This amendment is raised to answer Industry questions, to modify the RFRE, draft RFP, SOR, Mandatory and Rated requirements and extend the RFRE closing date.

From 269189.U000.E.PDF : 269189.U004.E.PDF Page 30: Appendix 2 Future Design Overview and Dataflow

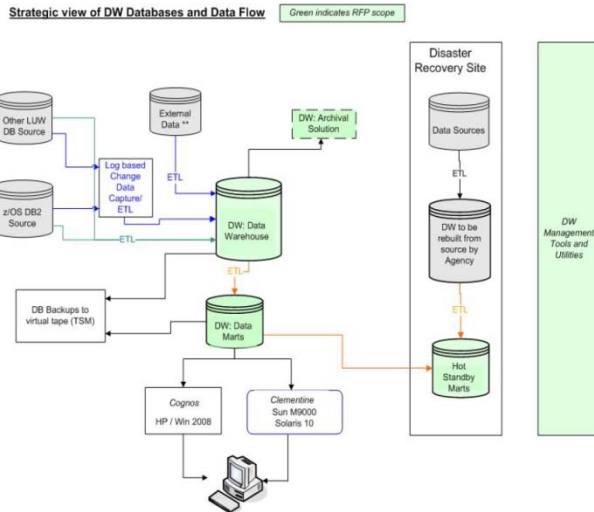
Enquiry: The diagram in Appendix depicts a strategic view of Canada’s future Data Warehouse. To help bidders propose the best possible solution, can Canada please provide the following additional information for the solution depicted by this diagram:

1. On page 5 of 269189.U004.E.PDF, Canada estimates that total current data requirements are not to exceed 200TB. Is the 200TB just for the Data Warehouse or for the Data Warehouse and Data Marts combined?
2. What is the estimated required data storage for the Data Marts?
3. What is the estimated required data storage for the Hot Standby Marts?

1. As per Table 2, Section 3.3 of the SOR, 200TB is the expected scaling for the 3 environments shown and are Data Mart based. Note that in 3.3.1 Canada may expect additional scaling should the successful bidder’s technology allow its usage to encompass more than the marts component of the data warehouse environment.
2. See answer 1. above.
3. See answer 1. above.
